IMPORTANT FIELD SAFETY NOTICE

Faulty bolts on counterbalance weight assembly

Product: Digital Linear Accelerator

Reference number (Field Change Order, FCO): 200 01 103 079

Fig. 1 Faulty bolt with 'OF' on face of bolt.

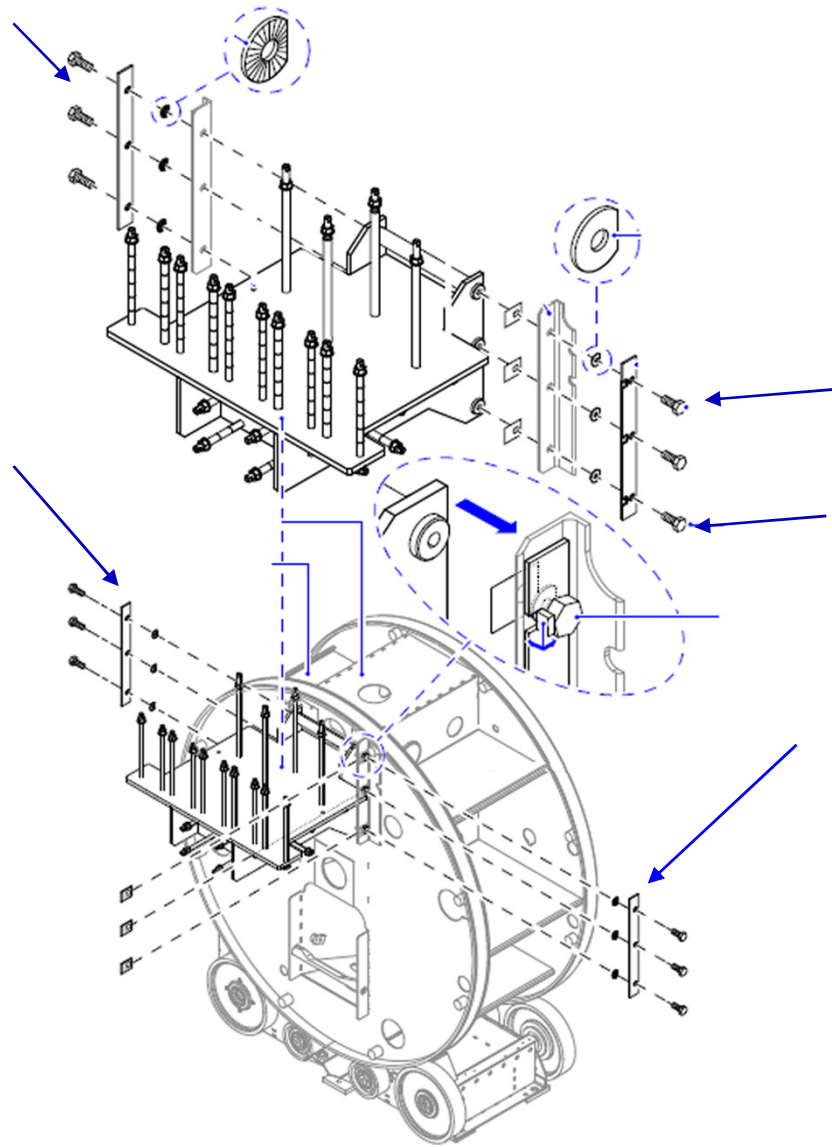
Scope:	Elekta Digital Linear Accelerators listed below are affected by this IFSN. 152807, 152943, 153060, 153255, 153300, 153348 – 153350, 153359, 153406, 153511, 153530 - 153532, 153534 – 153586, 153588 – 153620, 153622 – 153647, 153649 – 153670, 153672 – 153678, 153680, 153683 – 153685, 153691, 153696, 153699, 153702, 153710, 153712, 153713, 153715, 153717, 153723 – 153728, 153734. Machines outside this serial number range are not affected.
Description:	Elekta have identified an unserviceable batch of bolts supplied to install the counterbalance weight assembly on the gantry drum. Not all bolts in the batch are defective. Elekta will replace all the defective bolts that have the mark 'OF' on the head. If the bolts have a fault, the gantry drum is not stable and can fall and cause fatal injuries to all users. Contact your local Elekta representative to do a check on the bolts on the counterbalance weight assembly. The digital linear accelerator must not be used until these bolts are checked.

Clinical impact:	If the bolts are not serviceable, the gantry drum is not stable and can cause fatal injuries to all users and patients. The digital linear accelerator must not be used until the 'OF' bolts are replaced.
Solution:	The digital linear accelerator must not be used until the 'OF' bolts are replaced. If your system has the serviceable bolts, that is bolts without the 'OF' mark, you do not have to implement this ISFN.

<p>Elekta recommend that you replace the M20 x 50 mm bolts marked 'OF' on the gantry counterbalance frame immediately.</p> <p>The digital linear accelerator must not be used until these 'OF' bolts are replaced. Elekta recommend that you put the machine in a parked position at 0°, and attach the gantry locking straps.</p> <p>A Modification kit will be available as soon as possible which contains the correct bolts.</p>
Technical Reference:	CASE No 01938203
Contact:	If you have any queries about this Notice, contact your local Elekta representative.
